UNITED STATES PATENT AND TRADEMARK OFFICE

| 10/586,144 | 07/14/2006 | Donald H. Eason | USS-MDS20-PCT3-USNP | 4166 |

| Office Action Summary | Application No. 10/586,144 | Applicant(s) EASON ET AL. | |

DETAILED ACTION

Figure 1: Pivot coupler
orientated in Torrez

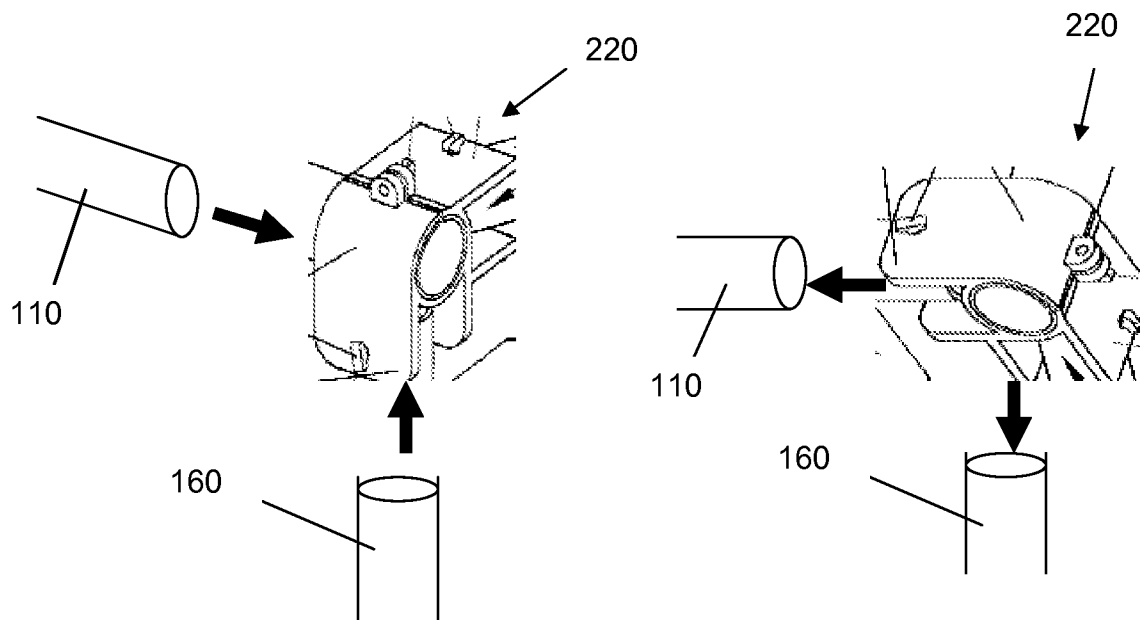
However the support apparatus disclosed by Torrez could be modified by rotating the pivot coupler (220) 90° as shown in Figure 2 below. This would provide the pivot coupler (220) to enable rotatable motion of the item support rail (110) about the substantially vertical axis defined by the rail support leg (150/160), and enable substantially purely vertical translatory height adjustment of the item support rail (120) relative to the rail support leg (150) through loosening and tightening thumb screw (225). Therefore, it would have been obvious to one of ordinary skill in the art at the time the invention was made to provide the pivot coupler to enable rotatable motion of the item support rail about the substantially vertical axis, where the pivot coupler enables substantially purely vertical translatory height adjustment of one of the item support rails relative to one of the rail support legs to which it is pivotally connected since it has been held that the provision of adjustability, where needed, involves only routine skill in the art. In *re Stevens*, 101 USPQ 284 (CCPA 1954). It has further been held that rearranging parts of an invention involves only routine skill in the art. In *re Japikse*, 86 USPQ 70. Doing so would provide a “wide degree of horizontal and vertical relative adjustment of percussion instruments” through a collapsible rack, as taught by Lombardi (column 2 lines 15-18).

However the support apparatus disclosed by Torrez could be modified by rotating the pivot couplers (220, 230) 90° as shown in Figure 2 above. This would provide the pivot couplers (220, 230) to enable rotatable motion of the item support rail (110) about the substantially vertical axis defined by the rail support legs (150/160), and enable substantially purely vertical translatory height adjustment of the item support rails (120/130) relative to the rail support legs (150/160) through loosening and tightening thumb screw (225). Therefore, it would have been obvious to one of ordinary skill in the art at the time the invention was made to provide the pivot couplers to be rotatable about the substantially vertical axis, where the pivot couplers are also height adjust couplers that enable substantially purely vertical translatory height adjustment of an item support rail. It would further be obvious to one of ordinary skill in the art at the time the invention was made to provide a portion of the item support rail to be sized to

In reference to claim 51, Torrez modified by Lombardi discloses a support apparatus as stated above, where the first and second compressible elements is shown in Figure 2 above to be installed around the rail terminus and a portion of the rail support leg (150/160). These references fail to explicitly disclose the cable to enter an item support rail without pre-drilling of either the item support rail or a portion of a rail support leg.
